CCNPP3COLA PEmails

A telecon was held on Wednesday, November 3, 2010, at the request of UniStar for clarification of RAI 268 (eRAI 5120), Question 02.05.04-27 – settlement calculation 2. The applicant's technical support contractor wanted to understand how the Cam-Clay model, used in the staff's confirmatory calculation, was calibrated on the available tri-axial stress-strain data. Staff were not able to provide sufficient detail without input from the support contractor that conducted the confirmatory calculation. Staff was able to reach the contractor after-hours and received clarifying information, attached to this email. Staff and applicant representatives will hold an additional telecon Thursday afternoon, November 4, to continue the discussion.

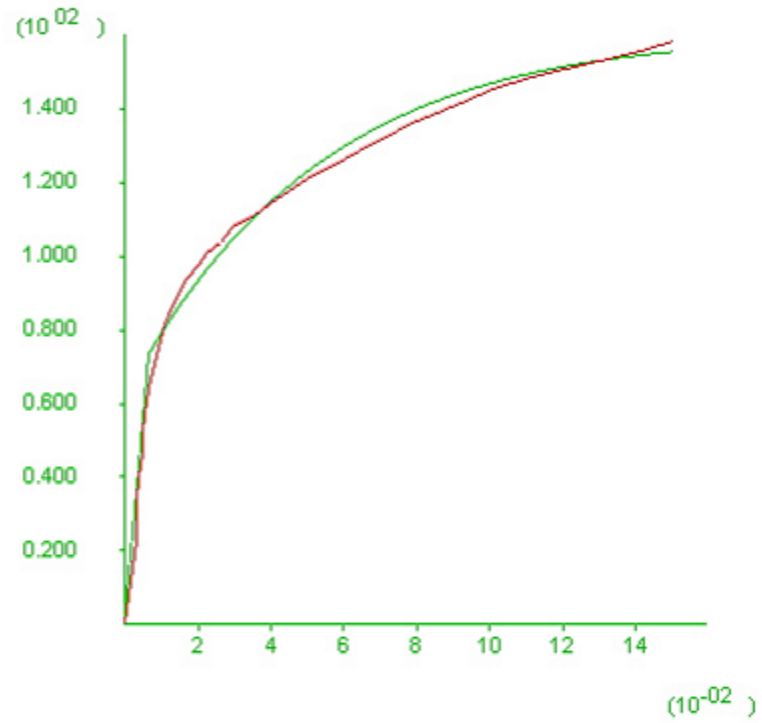
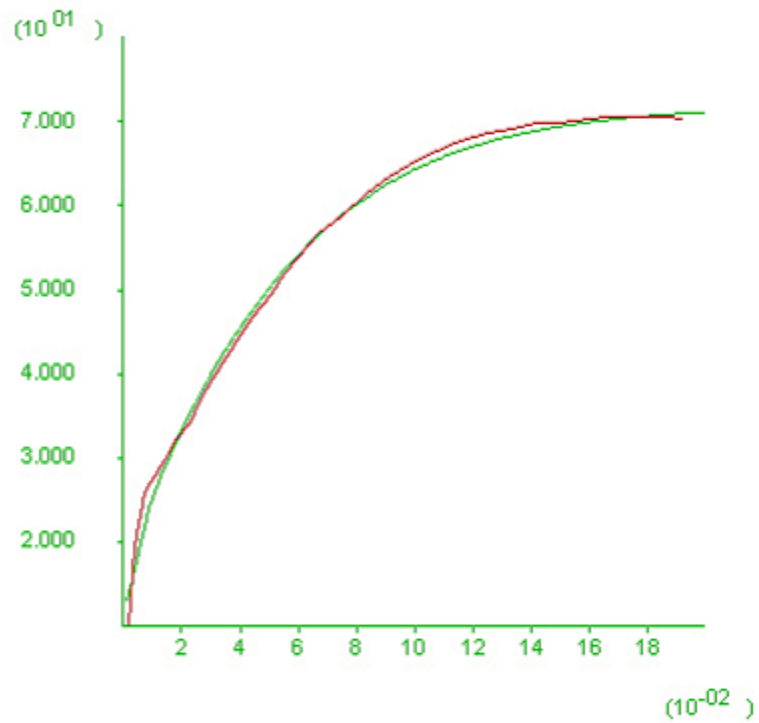
“We basically started with consolidation data provided in the calculations (which are inputs from the cam-clay model) and adjusted those parameters for a single finite element until the computed stress-strain behavior matched the test data. I have attached some figures that show this match.”
